Byproduct Material License No. 22-08799-02  
Response to NRC Comments Dated January 11, 1990  
Pathfinder Decommissioning Plan - Response to 1/90 Comments

COMMENTS AND RESPONSE ON PATHFINDER DECOMMISSIONING PLAN

Figure 2-5 a

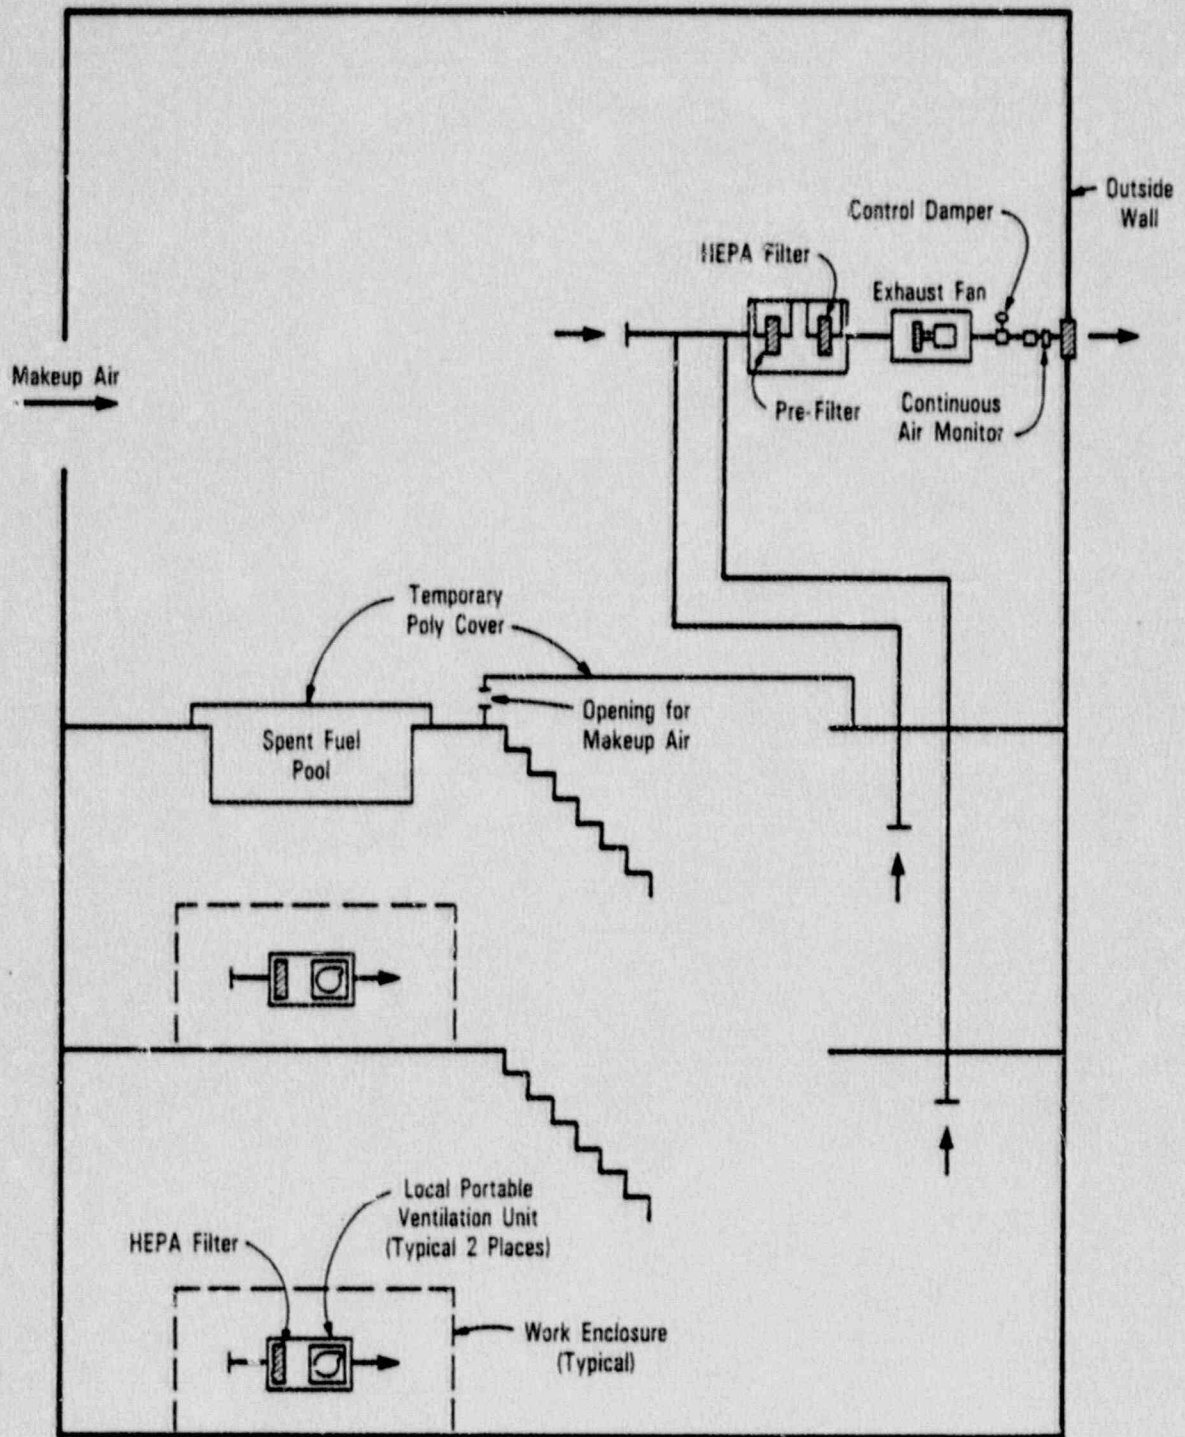
Please confirm that temporary ventilation equipment will exhaust inside the RB and FHB, and that this exhaust air must pass through a second HEPA filter in the building exhaust(s) before release to the environment. Please provide a diagram of the building exhaust system, and indicate where the local area ventilation equipment will exhaust.

The temporary ventilation equipment will recirculate air inside the Reactor and Fuel Handling Buildings. Recirculated air will pass through a HEPA filter located inside the temporary ventilation equipment. This exhaust air will pass through a separate HEPA filter in the building ventilation system before being exhausted to the atmosphere. Refer to Figures 2-5a and 2-5b for diagrams illustrating the above system.

PATHFINDER  
FIGURE 4-1

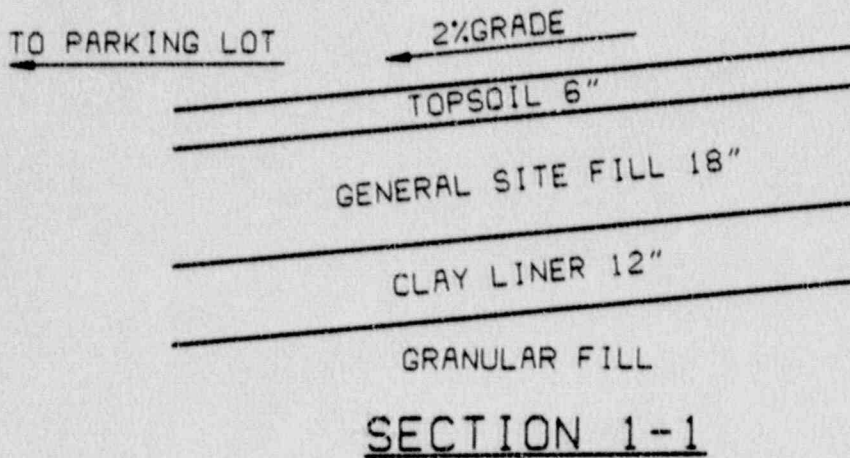
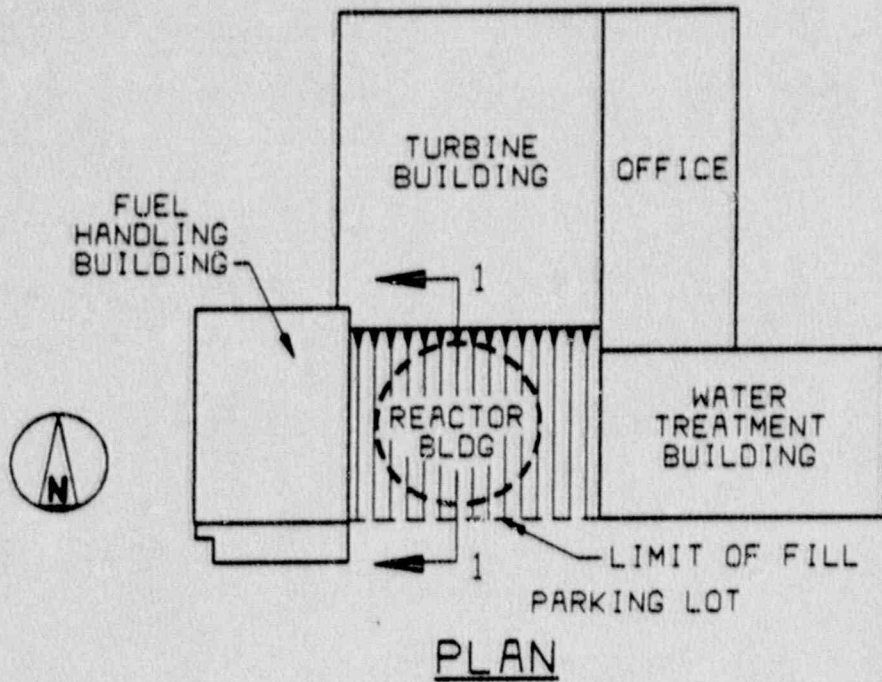
Please provide diagrams and text which illustrate the size, shape, location, thickness and permeability of the clay and earth caps to be placed over the buried RB. Please provide bounding estimates of the total inventory by nuclide of residual activity in the concrete to be left in place (include all assumptions and data), the mass of concrete to be left in place, the projected water flow rate into the buried containment, and the time required for the "water table" in the buried containment to rise to the upper edge of the buried structure.

Figure 4-1 shows the size, shape, location, and thickness of the clay cap. The clay cap as designed has a permeability of  $10^{-6}$  cm/sec. The clay cap has a 2% grade sloping away from the turbine building to avoid any future ponding.

Illustration of Typical Milling Cutters

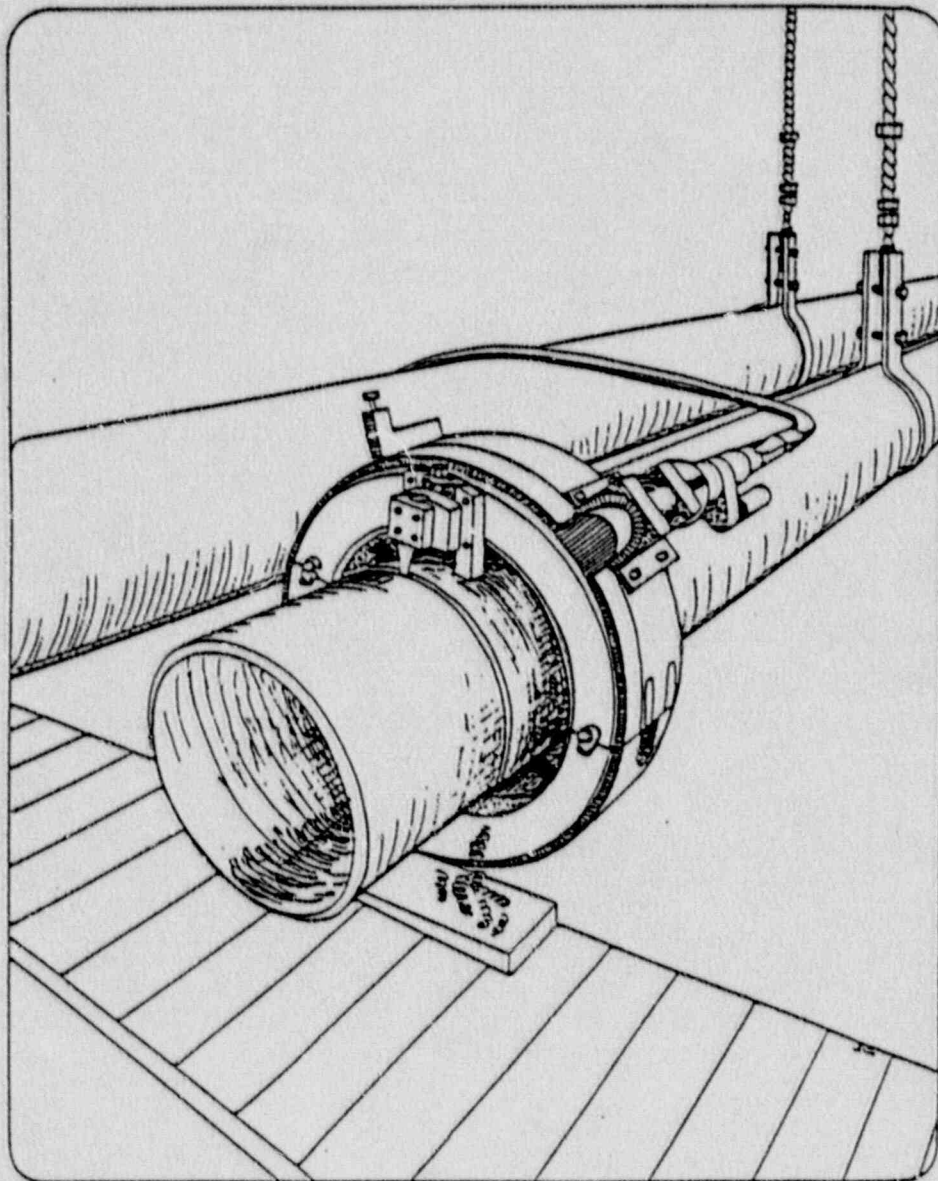
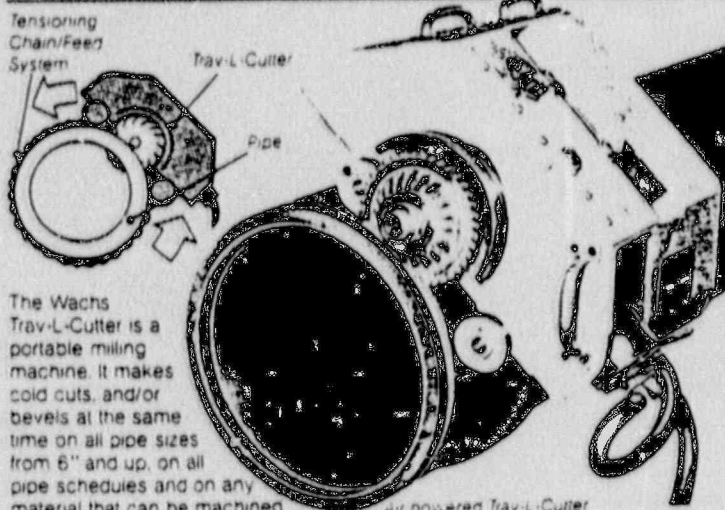
Please provide a description of the "milling cutter" and how it will be used.

The "milling cutter" is a pipe cutting machine that is mounted on the outside of the pipe. These machines can be air or hydraulic driven. These machines can sever, bevel and counter bore in one setup. Pipe cutting machines will be used when thermal cutting is not feasible. Two typical models of such equipment are presented in Attachment 1.

TGM Model N1002/8767 Radiation Detector

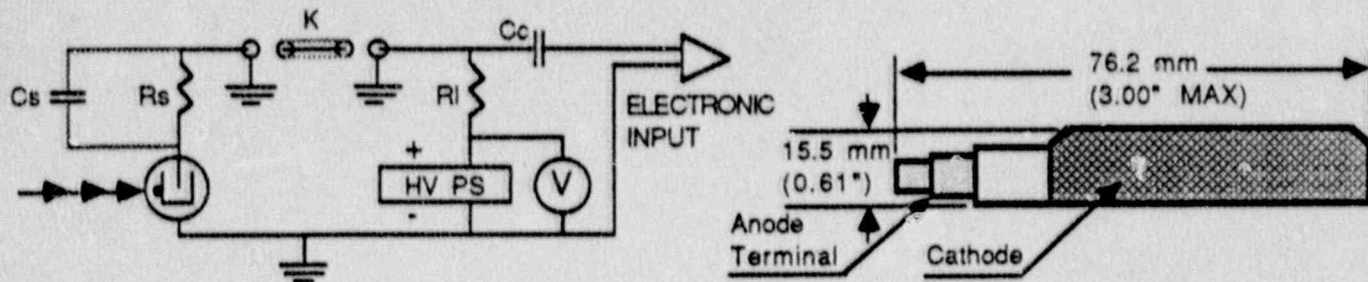
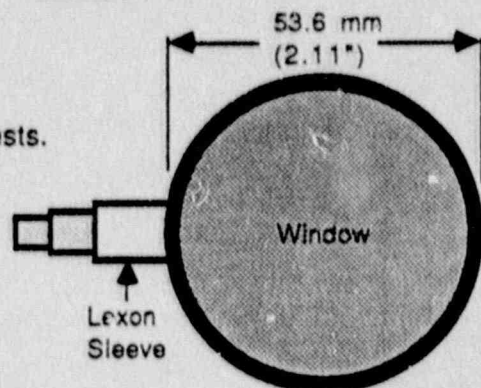
The stated release criteria for fixed radiation is "100 CPM above background... using a pancake GM survey meter at 1 cm." Please convert CPM to dpm, and indicate the minimum efficiency and size (area) of the pancake survey meter to be used. Please indicate the minimum detectable contamination in units of dpm per 100 square cm.

A typical radiation detection instrument to be used on the Pathfinder Decommissioning Project is a TGM Pancake GM tube detector, model number N1002/8767 (see Attachment 2 for information on the N1002/8767 detector).
